FLOOD CONTROL PERMIT NO. FC-36

Application For Flood Control Permit Within The State Of South Dakota

FLOOD CONTROL PERMIT FC-36

City of Sioux Falls Flood Control System

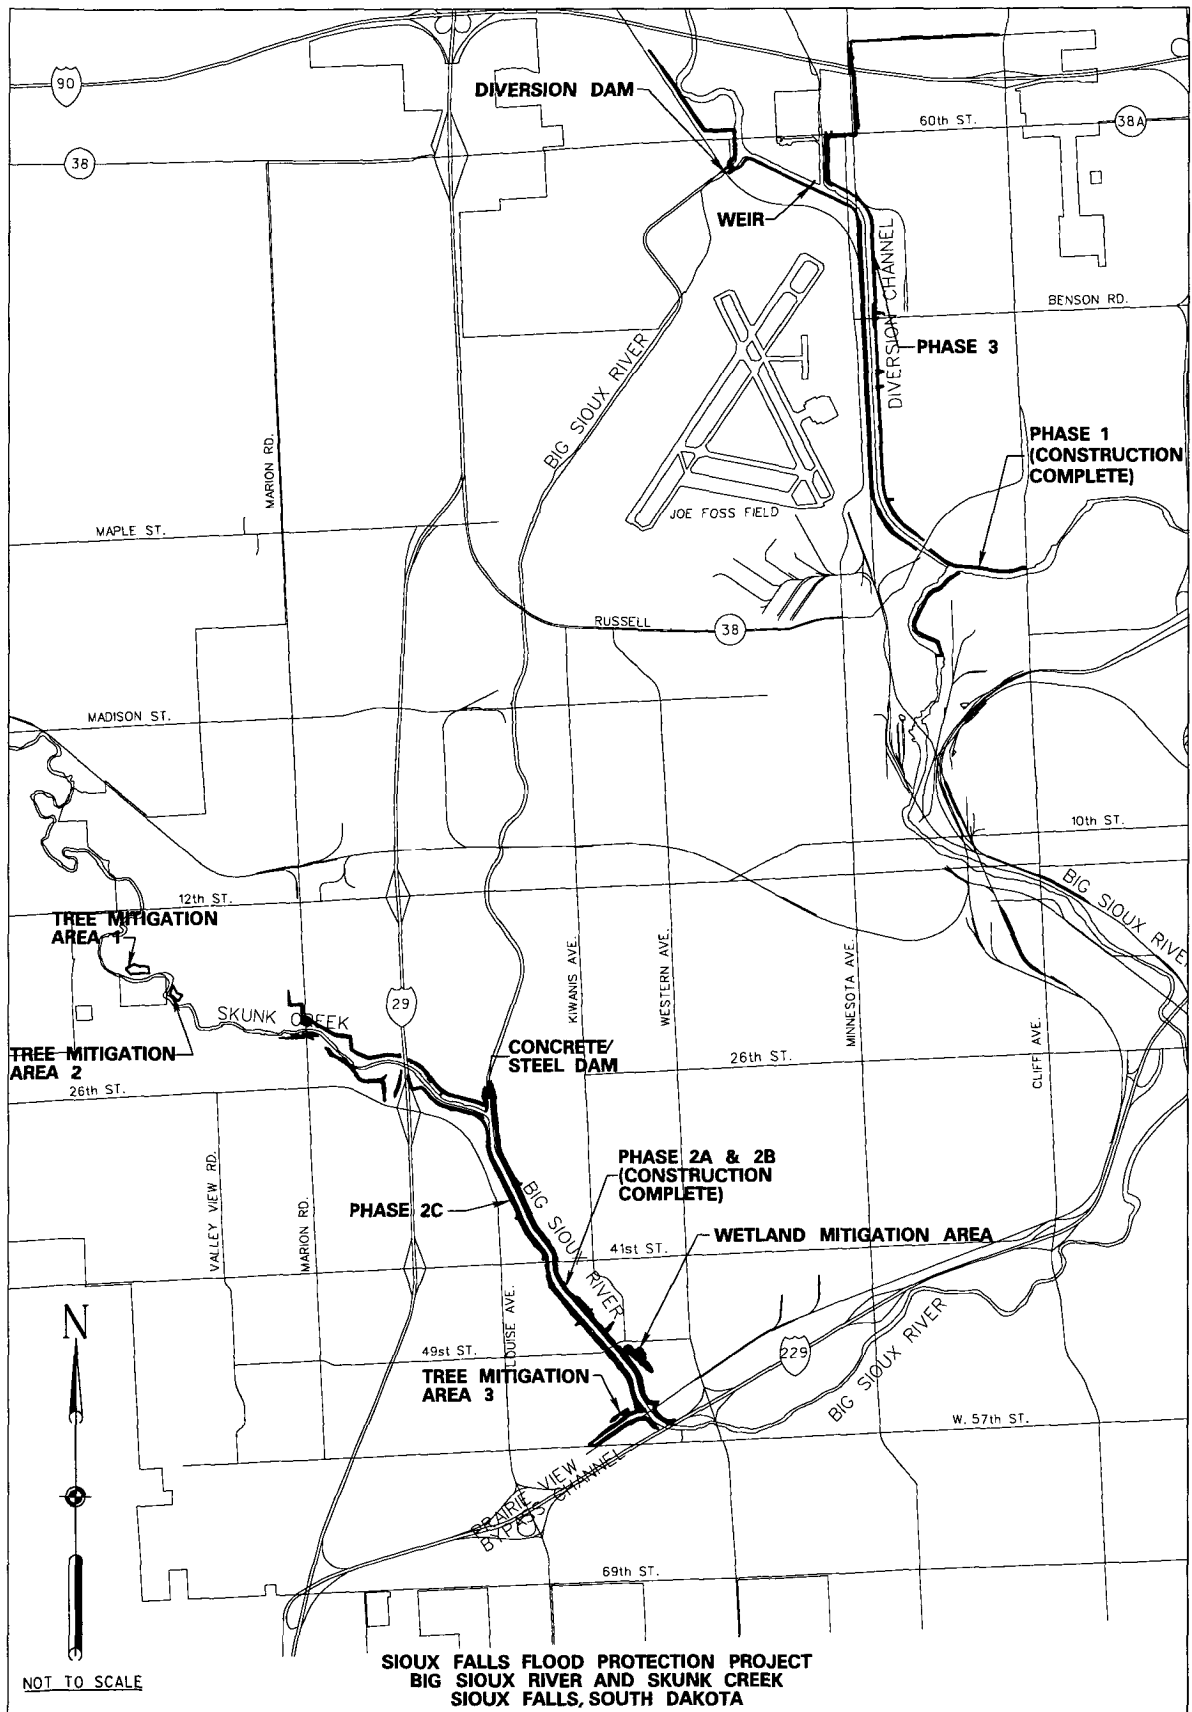
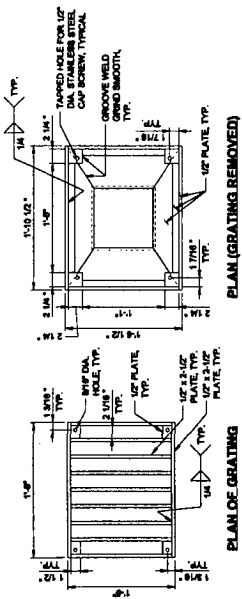
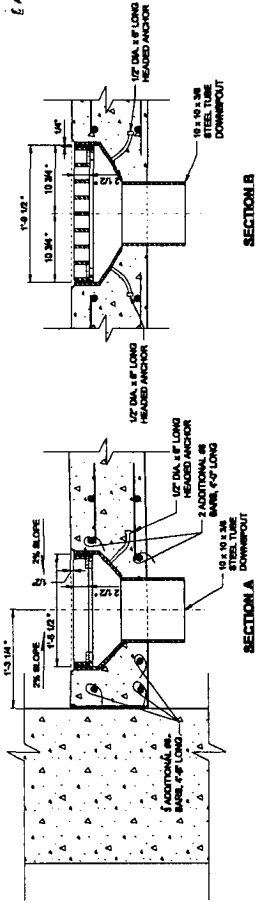
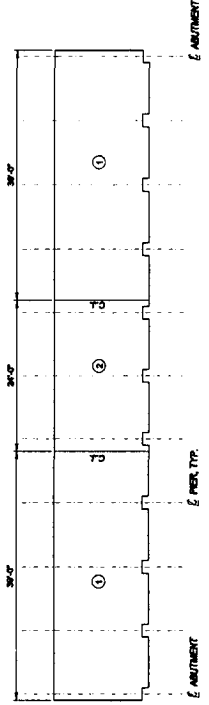
1. Topo Map - OK
2. Dam Axis Profile - OK
3. Dam Max. X-Sec. - OIS
4. Area Capacity - OK
5. Inlet Details - OIS
6. Spillway Discharge - OIS
7. Spillway Details - OIS
8. Specs - OK
9. EPP - N/A Cat 3 - OK
